Access Compliance Report

Public Rights-of-Way

(Curb Ramps)

Intersection ID: 44450	Main Street: BAYVIEW_PY	Cross Street: DONNELSON_COMMON_CT	Location: SE
ADA ID: 7342B9E65FBB	Ramp Type: PerpDiag	Initial Pass/Fail: Fail	Overall Compliance: No
Severity Score: 8.75			
Codes/Mitigation Info/Possible Solution		Field Measurements/Component Compliance

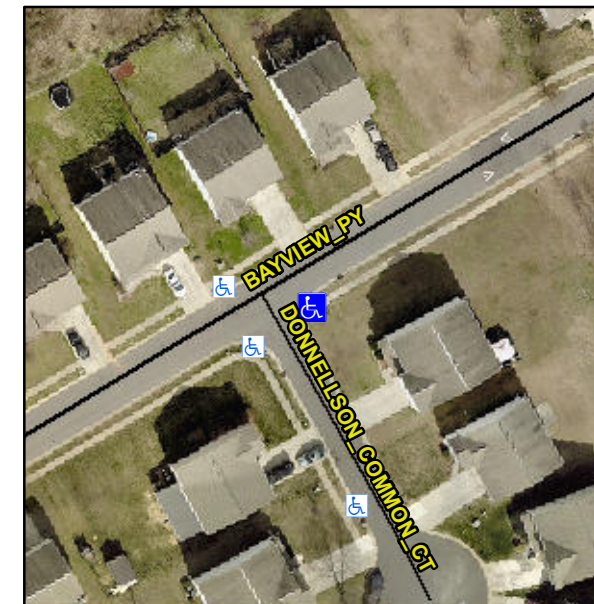
Not Found, R304.5.1

Remove & Replace Curb Ramp With Two New Directional Ramps or Equivalent.
